INDIANA DEPARTMENT OF TRANSPORTATION

AGENDA

November 19, 2020 Standards Committee Meeting

RE: Agenda for the November 19, 2020 Standards Committee Meeting

SECTION THROUGH APPROACH

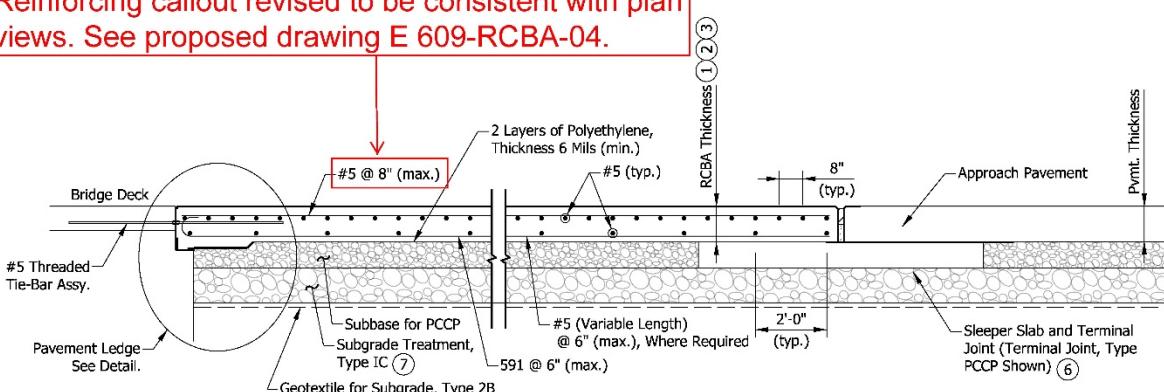
Reinforcing callout revised to be consistent with plan views. See proposed drawing E 609-RCBA-04.

PAVEMENT LEDGE DETAIL

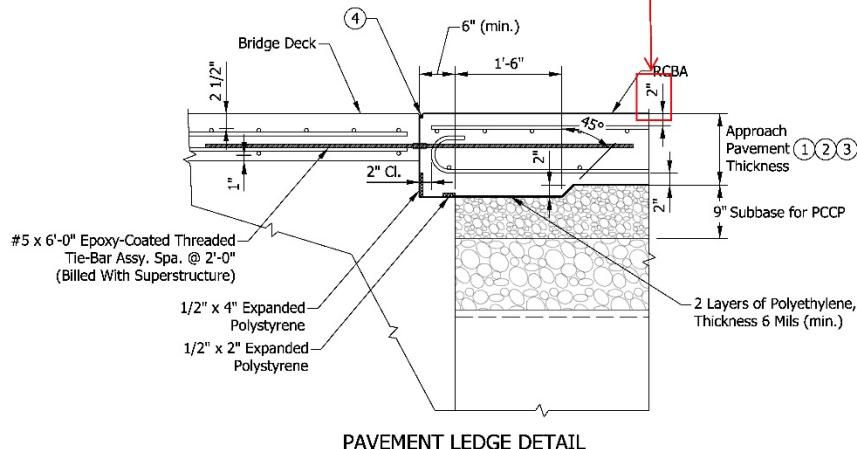
Top clear cover revised to match bridge deck. See proposed drawing E 609-RCBA-04.

E 609-TBAE-01 RCBA EXTENSION FOR BRIDGE RAILING TRANSITION TFC, TPF-1, TPF-2, TPS-1, OR TPS-2 (existing, shown markups)

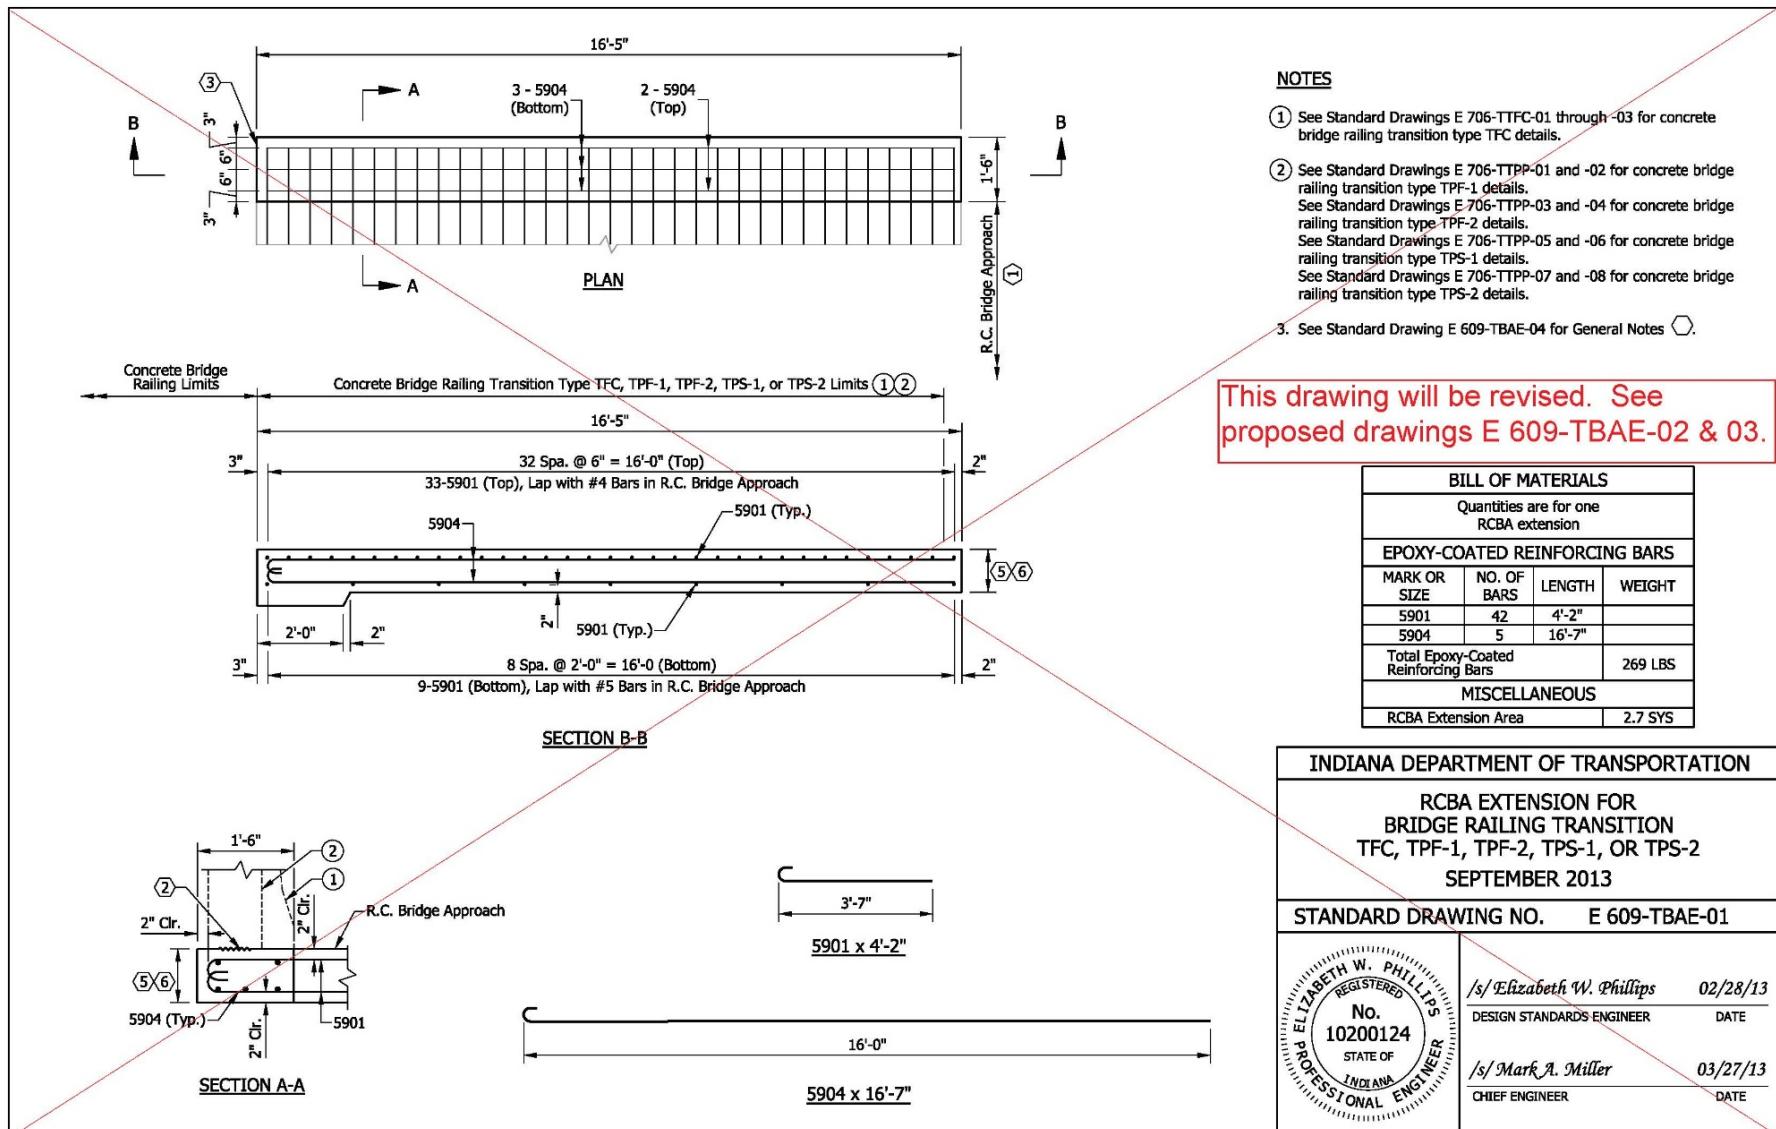
PROBLEM(S) ENCOUNTERED: The reinforced concrete bridge approach (RCBA) extension for bridge railing transition drawing series (TBAE) hasn't been updated to reflect changes to the RCBA Standard Drawings that were implemented in 2014. As a result, the reinforcing in the TBAE series isn't consistent with the reinforcing in the RCBA series, which causes constructability concerns. The current TBAE series also lists several bridge railing types that are no longer INDOT standard bridge railing types. Also, the clearance from the top of the RCBA to the top layer of reinforcing bars was decreased from 2 1/2" to 2" when the RCBA Standard Drawings were revised in 2014. This has reduced the amount of protection for the reinforcing bars and has also increased the risk of snagging reinforcing bars during future milling and overlay operations.

PROPOSED SOLUTION: The TBAE series has been revised to: space the transverse bars with the typical transverse bars in the RCBA, revise the orientation of reinforcing mats to be consistent with the RCBA reinforcing, remove the hooks on the longitudinal bars to reduce congestion, update the width and length of the extensions to be consistent with the current bridge railing transitions, and increase the cover on the top layer of reinforcing to 2 1/2". The RCBA series has been revised to increase the cover on the top layer of reinforcing to 2 1/2", as well as some minor editorial changes.

E 609-TBAE-03 RCBA EXTENSION FOR BRIDGE RAILING TRANSITION WFC (existing, shown markups)

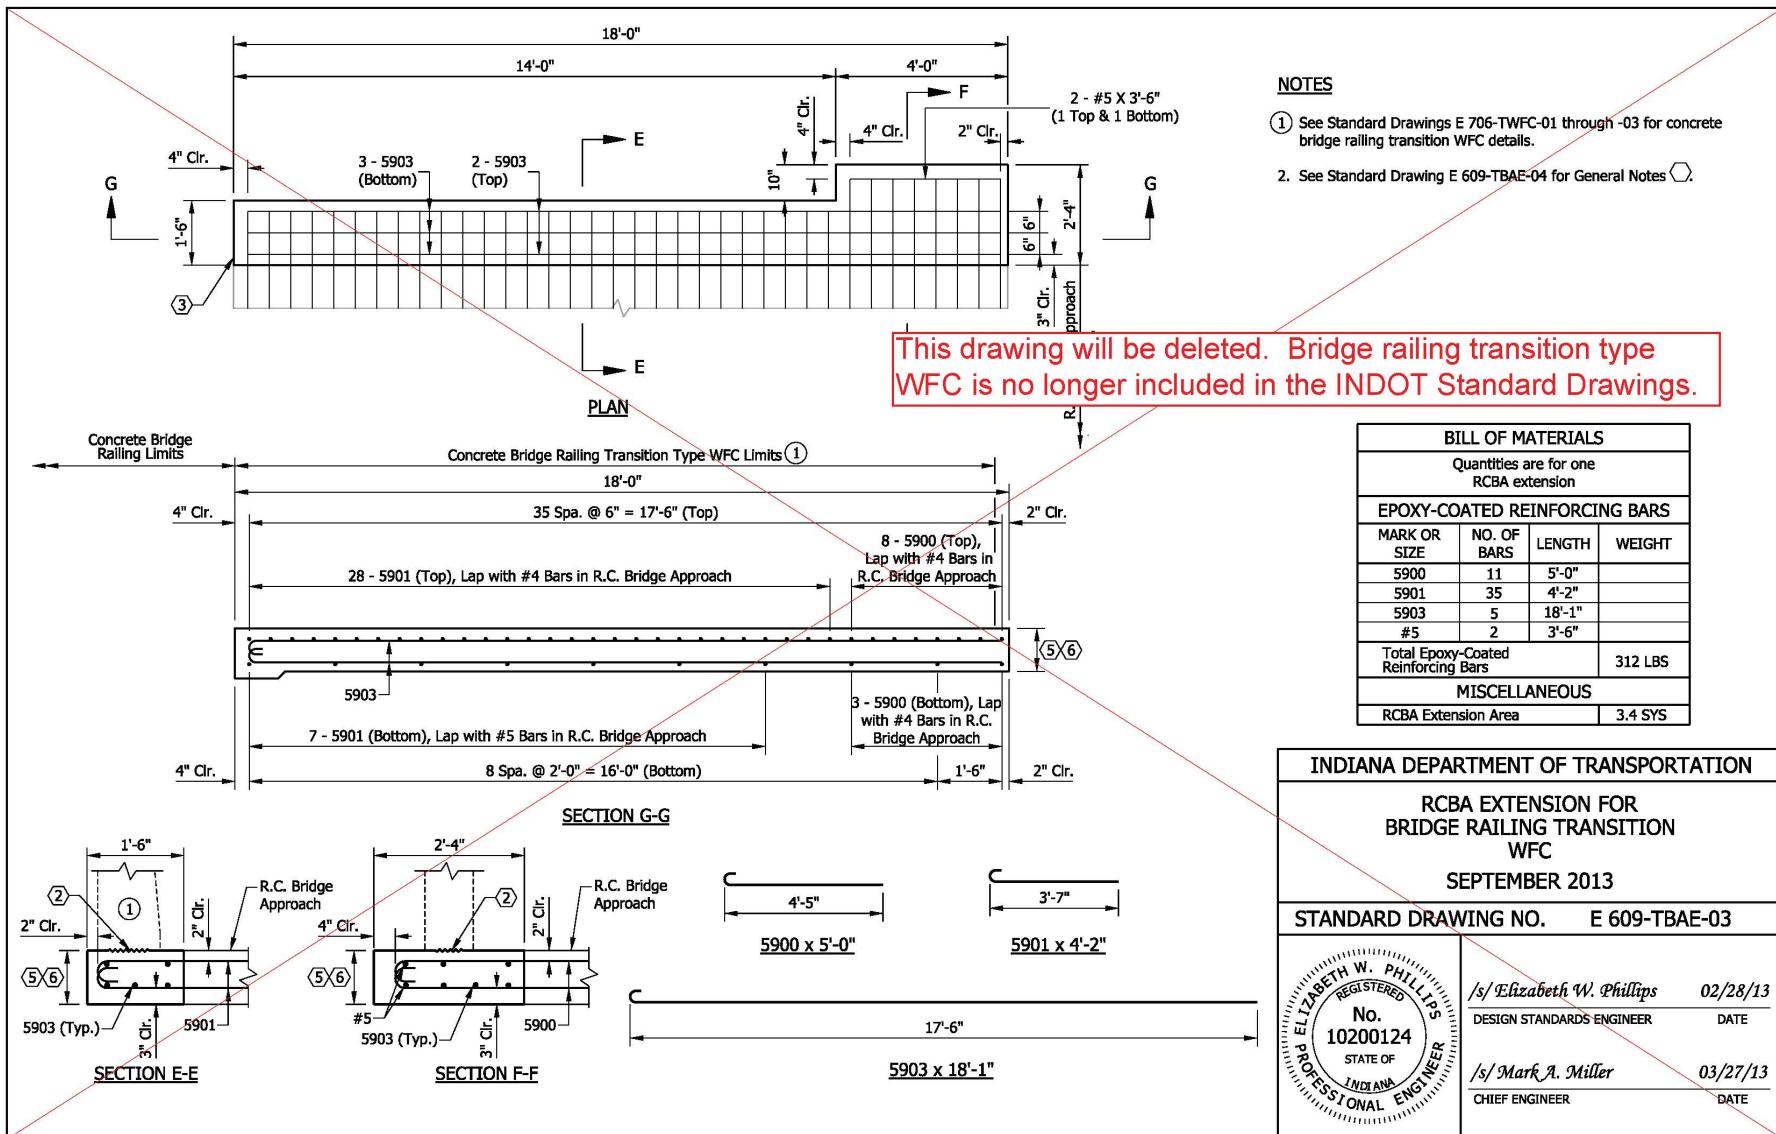
This drawing will be revised. See proposed drawing E 609-TBAE-01.
